**MEP RENOVATIONS - JENNINGS HALL
SOUTHERN CONNECTICUT STATE UNIVERSITY
NEW HAVEN, CONNECTICUT
PROJECT: BI-RS-249**

ADDENDUM NUMBER ONE

DECEMBER 14, 2009

SECOND FLOOR PHASING DIAGRAM

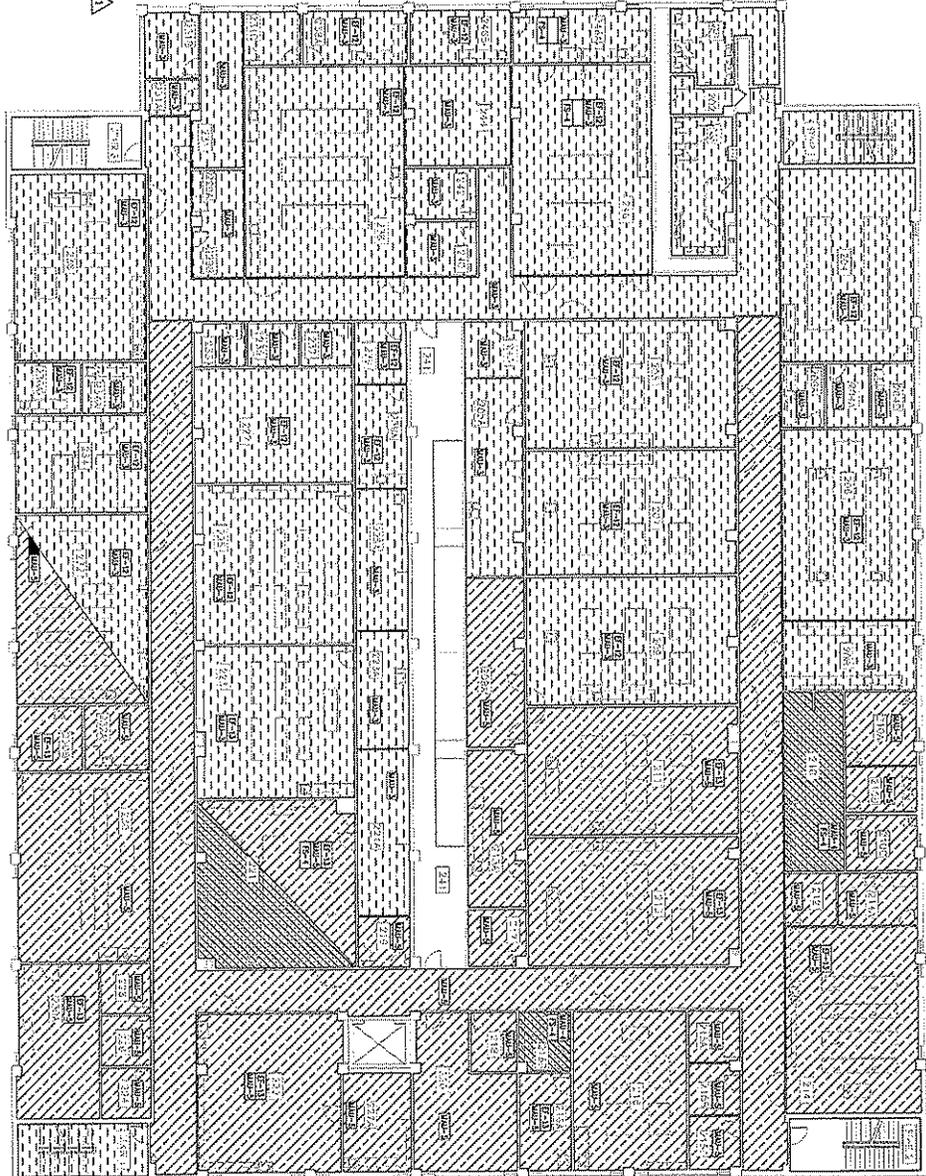
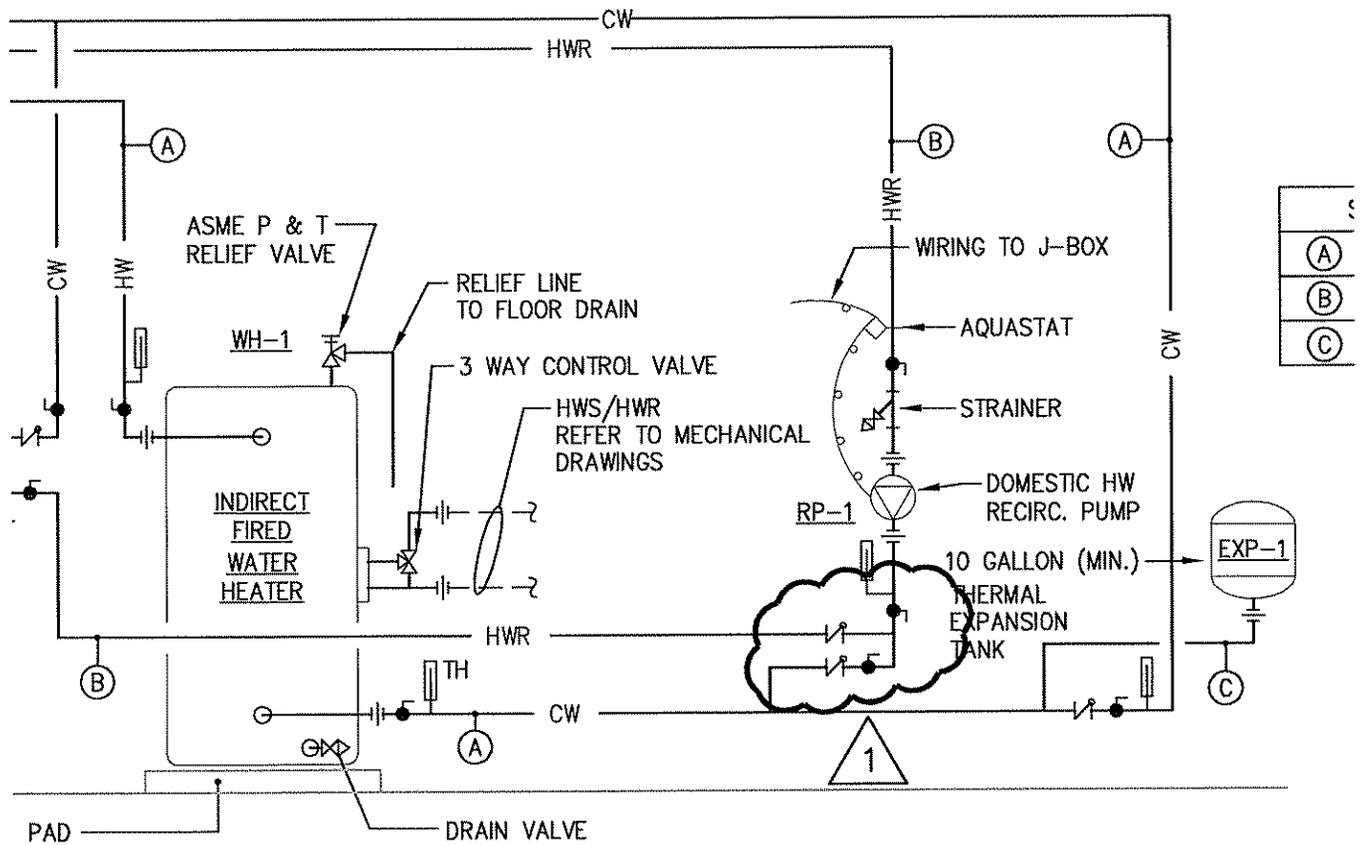
In section 011216, Work Sequence, item "T" addresses the duration of the phases of the project. Per the phasing plan there are 5 phases. The phasing notes on the drawings are the same as those in this section of the specification. During the pre-bid conference you mentioned that the project schedule might consist of a summer – winter – summer type schedule to minimize interruption to the facility. I interpreted the phasing to mean that once all the necessary materials are on hand, we could begin the construction phases and that one phase would roll to the next and so on through project completion. Your comments the pre-bid seemed to indicate starts and stops with lapses of time in between. Item "J" in this section indicates that the order and schedule of the phases will be determined at a later date prior to construction. Depending on whose interpretation of the project sequence is correct will significantly impact lost time and down time with an impact on overall general conditions costs. If the project definitely requires construction to occur only during specific months or time periods during the course of the project, this should be clearly indicated at the time of bidding.

The schedule dates and phasing has been revised. Refer to the phasing drawings PH-101, PH-102 and PH-103.

DRAWING NO:
SKP-1
DATE: 12-11-09
SCALE: NONE

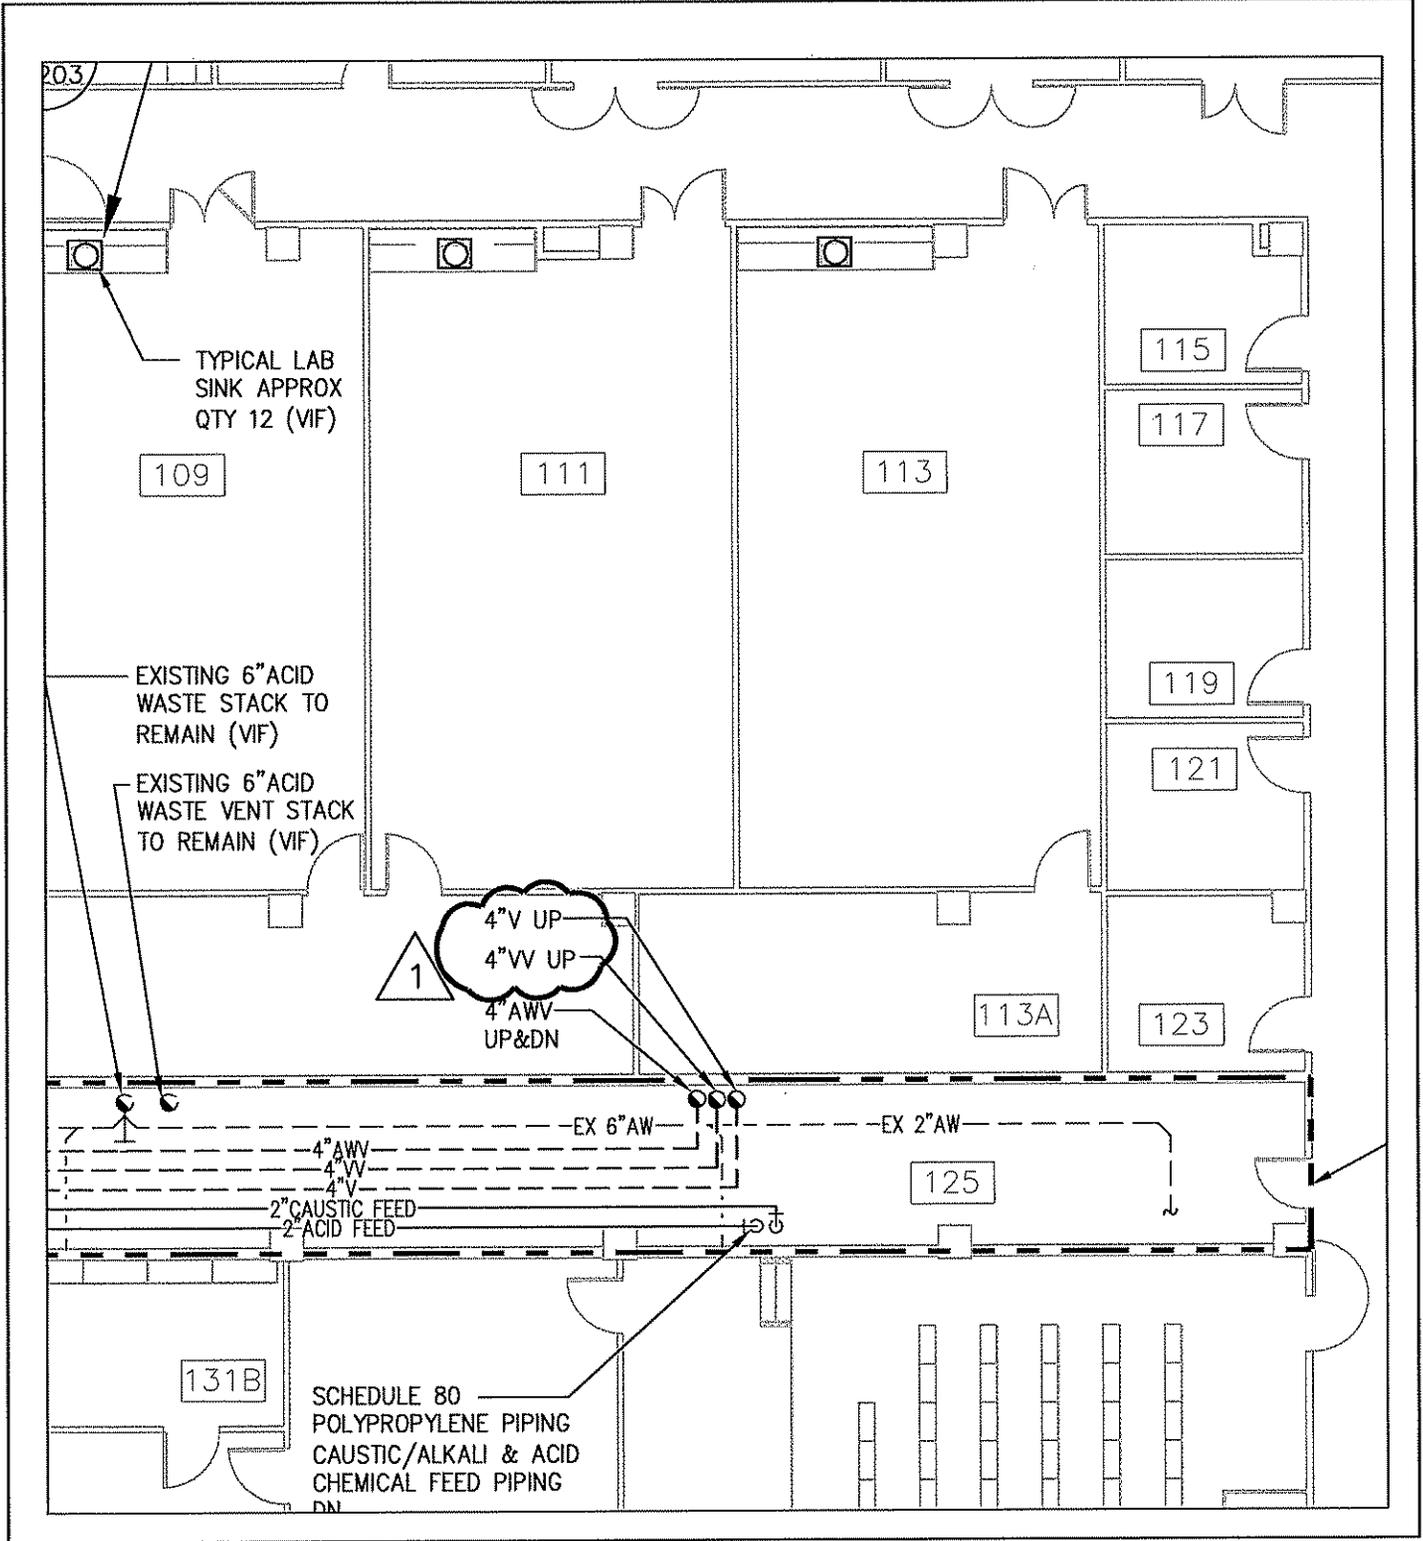
DRAWING: P-201 Detail 2: Water Heater Piping Diagram

Revised the detail. Refer to SKP-1.

DRAWING NO:
SKP-2
 DATE: 12-11-09
 SCALE: 3/32"=1'-0"

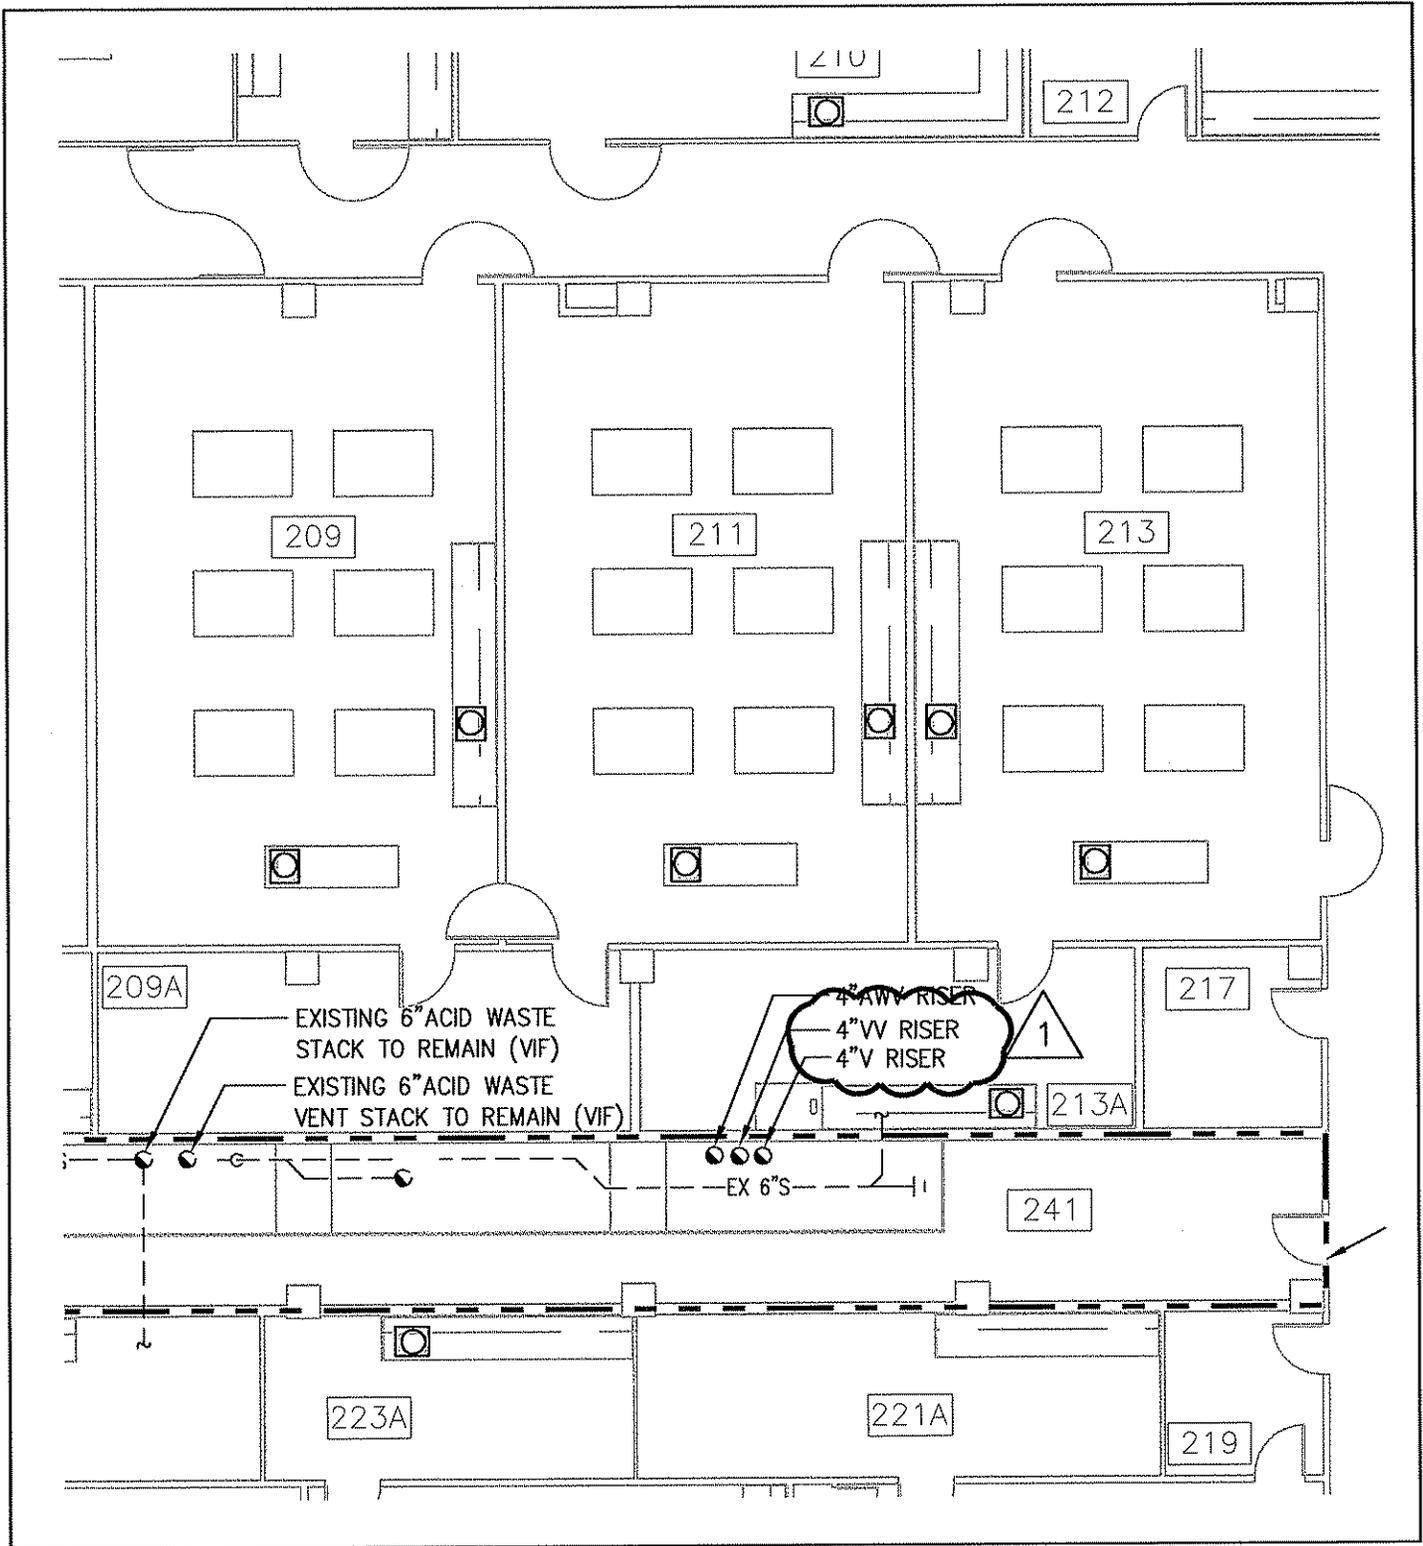
Revised the neutralization tank vent and vault vent notation. Refer to sketches SKP-2, SKP-3, SKP-4 and SKP-5.
